From: Engineering Department of Tecumseh Products Company  
 To: Customers worldwide  
 Date: February 4<sup>th</sup>, 2026  
 Subject: Clarification on suction tube identification and label update for AL compressors

## PRODUCT BULLETIN

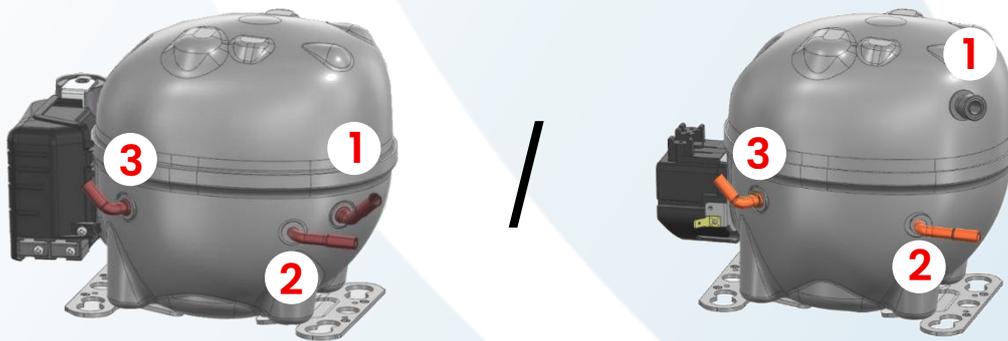
We would like to inform our customers that the arrow printed on the product label is intended to identify the **side** of the suction tube. After reviewing, the label design has been updated to make this intention clear. The arrow has been repositioned and the text changed from **suction** to **suction side**. This updated label will be applied to all AL compressors produced from March 2026, onwards.

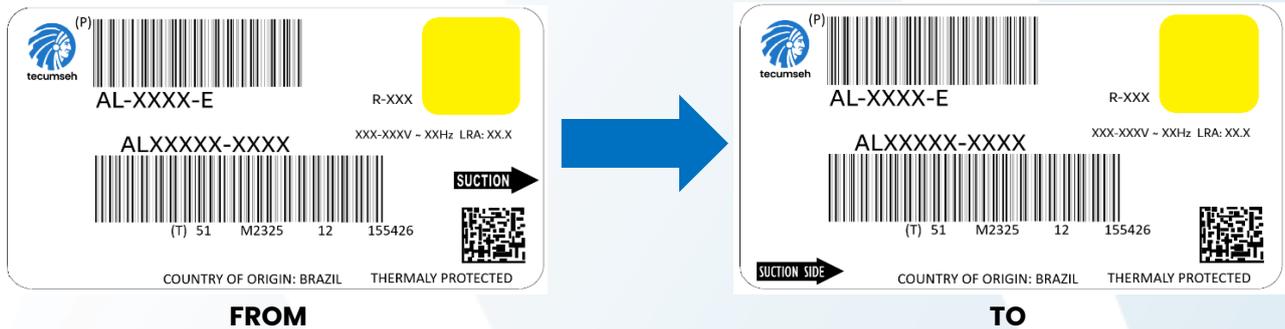
To correctly identify the tubes, consult the instruction manual or technical documents on our website, which remains the primary reference for installation and connection guidance. Additionally, we present the connections below.

**1 = Suction**

**2 = Discharge**

**3 = Process**
